Manual for fixing hanging problem of SMART Relay4ch20A/6ch16A/8ch16A of Batch 3

Manual Updated Date: Aug 31, 2012, V1.0

- A. This document is used for resolving hanging problem of relay 4ch20A/6ch16A/8ch16A of batch 3.
- B. Relay PCB Version of Batch 3: V2.1, Updated date: Aug 2011
- C. Newer version V2.2 has already been resolved this problem from the PCB layout

2.3.1 R19 (Resistor 1K)

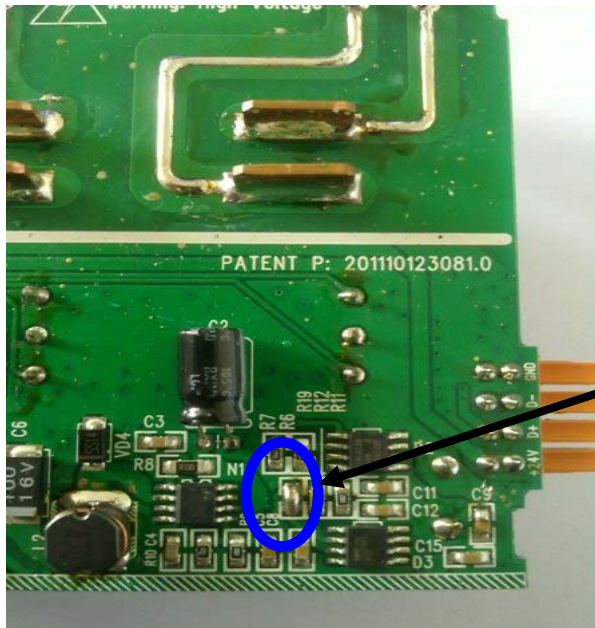
STEP 1. Remove resistor R19 from PCB

this resistor of R19 will be used in other area, please keep it and don't throw it.

STEP 2. Connect Point A and Point B together by solder wire

After connected point A and Point B, It will look like as the picture.

2.3.2 Solder resister of R19 (1K) on point C and Point D

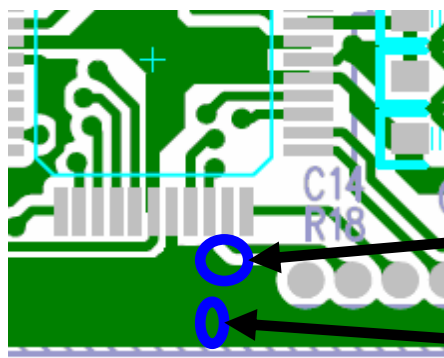
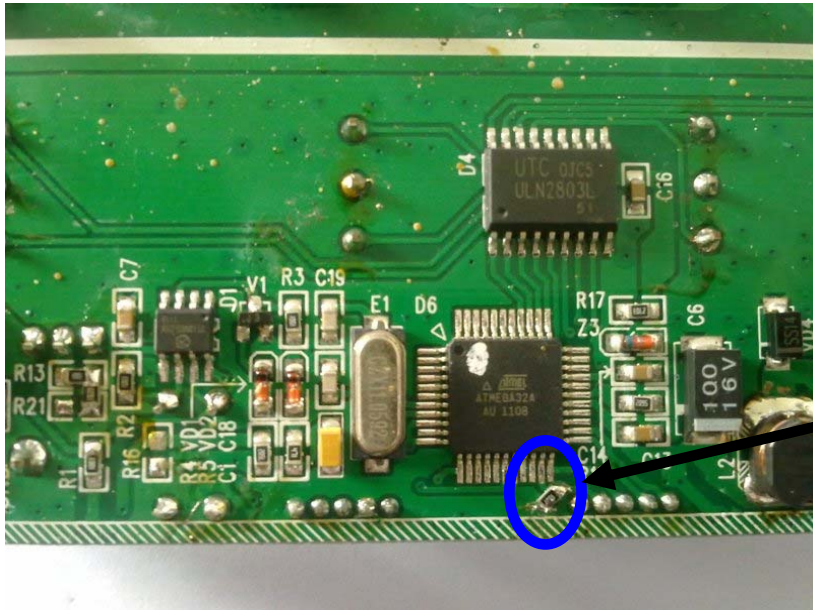
Point C, Point C is on the small track

Point D

STEP 3. Since there are no soldering points for Point C and Point D, so you need to use knife to erase a little green area on Point C and Point D as soldering points

STEP 4. Solder resister of R19 to point C and D, direction of resister is not sensitive.

R19 has been fixed on Point C and D.

2.3.3 Change the location for R21

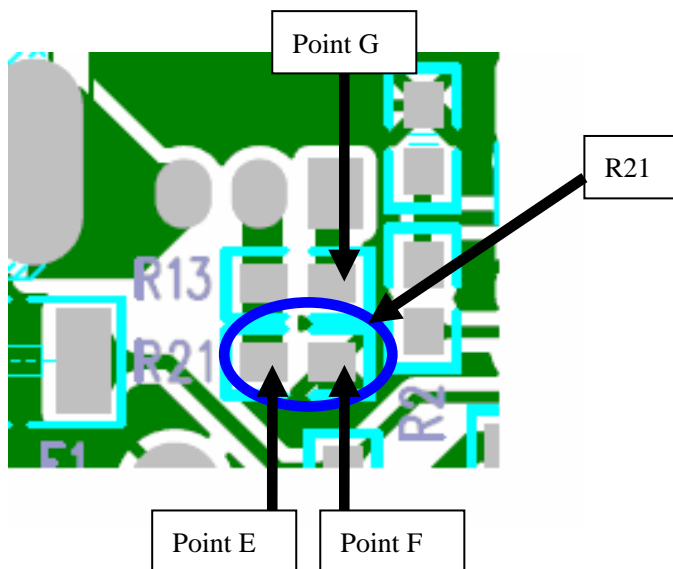
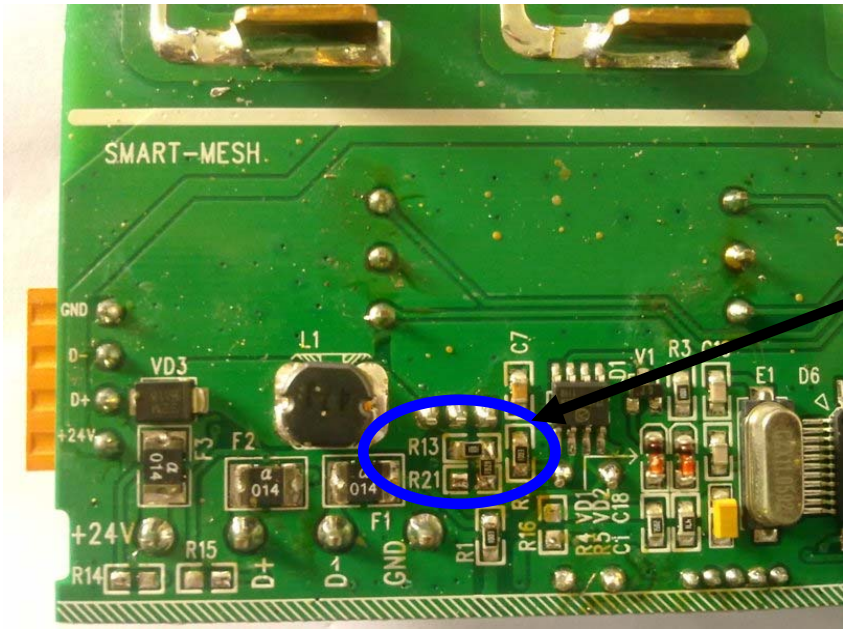
No need to change R21 for Relay6ch16A and Relay8ch16A, the following operations are only for Relay4ch20A.

STEP 5: Remove R21 from the PCB

STEP 6: Solder R21 on Point F and G, the direction of resistor is not sensitive.

R21 has been fixed.
